## Auckland Council

### Request for Further Information under s.92 Resource Management Act 1991

### Notices of Requirement by Auckland Transport for the South Frequent Transit Network

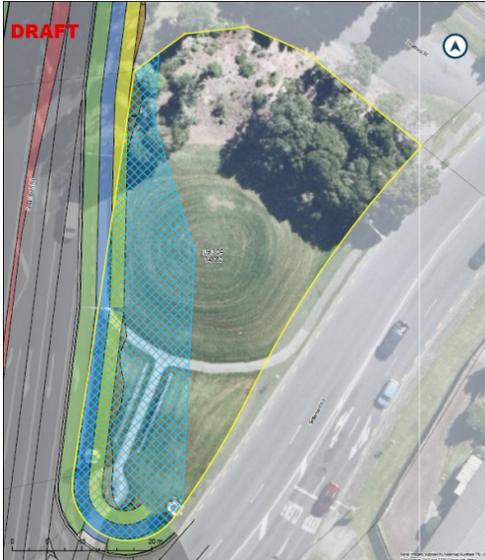
SIA8	SIA, Section 6	Please explain why the Franklin Local Board area is not included as part of the 'wider community' – social area of influence.	The Project will likely have social impacts on people living in Drury, Pukekohe, Karaka, Bombay and Ardmore and other areas who either commute through or access schools, community facilities, services and businesses in the Project area. However, construction and operational impacts (positive and negative) on this wider community does not appear to have been reflected in the SIA.
SIA9	SIA, Section 8.2	Please provide further information regarding job creation, education and training opportunities during construction	These opportunities are significantly beneficial for NEET and young school leavers in the local areas and should be pursued under a pro-active strategy with local training partners and community stakeholders. However, this is not reflected in the proposed Conditions. Please explain how such an approach should be considered and how this is to be implemented in order to achieve the proposed positive effects.

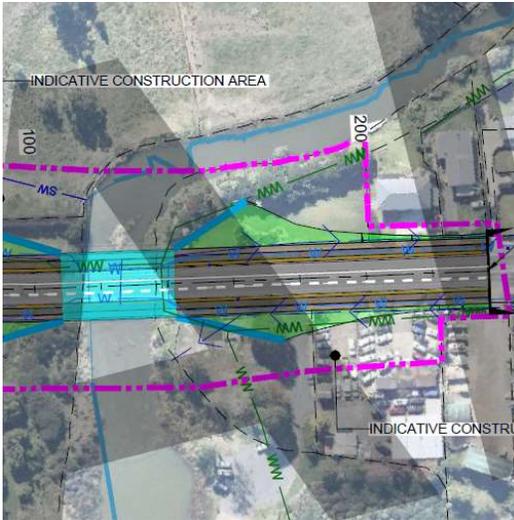
UD3	AEE, Appendix A: Assessment of Alternatives p13	Please include illustrations of operative and proposed plan changes referenced within the AEE for clarity and completeness	The Assessment of Alternatives outlines a number of approved plan changes in the wider area. An illustration of the areas included within these plan changes would assist with understanding the impact this will have on the project area.
UD4	UDE Appendix A - Part 5 Sheet 13	Please provide urban design assessment of the impacts of the proposed closure of the Beaumonts Way/Weymouth Rd intersection.	The proposed closure of Beaumonts Way is identified in the General Arrangement drawings and UDE Appendix A sheet 13. This proposal will reduce connectivity and permeability for vehicular traffic to Manurewa town centre/Southmall. Please provide an assessment that addresses why this road is proposed to be closed, what provisions are proposed for active modes to access the bus and rail stations and the town centre, and what impact this will have for residents of Beaumonts Way and neighbouring streets (positive and negative).

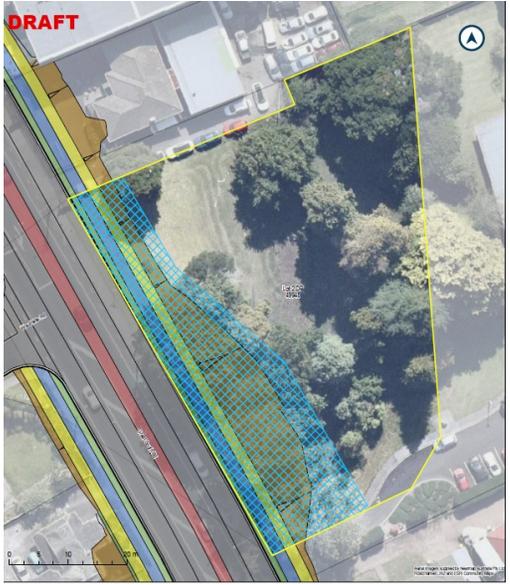
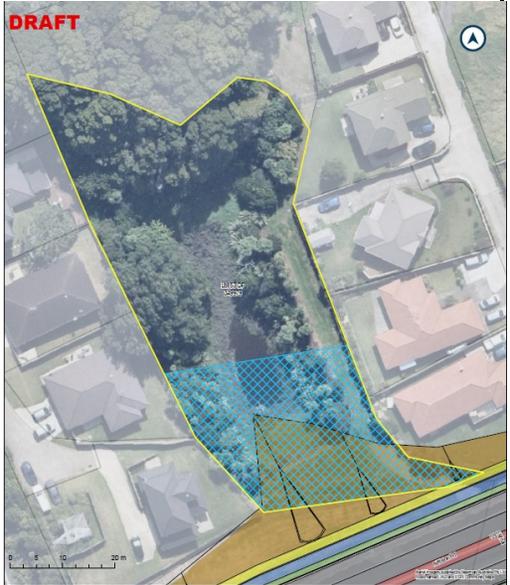
Issue identifier	Reference (Report name, section, page number)	Further Information Requested	Reasons for further information request
			space edges including Alfriston Park (UDE Appendix A sheet 14)
<b>Open Spaces (Parks)</b>			
PP1	AEE General and Section 10.3.3	<p>Please prepare a standalone report that addresses each of the areas identified below. The report should include, but not necessarily be limited to, the following elements:</p> <ol style="list-style-type: none"> <li>1. A detailed description of the physical work required or potentially required within each affected site, including construction and permanent changes post-construction.</li> <li>2. Assessment of potential environmental effects specific to the park or reserve area.</li> <li>3. Identification of potentially affected users of the space, with a specific focus on community groups and activities, such as RSL, sporting clubs etc. that may</li> </ol>	<p>The request for a standalone report is twofold: it aims to consolidate assessment and information across existing expert reports and plans, and to address information sufficiency gaps identified during the review of the application material. By creating a focused and comprehensive assessment of impacts on affected parks and reserves, the report is crucial for a nuanced understanding of community impacts, service disruptions, and mitigation or compensation strategies. This information will streamline the review process and provide the holistic evaluation essential for specialist parks planning input.</p>
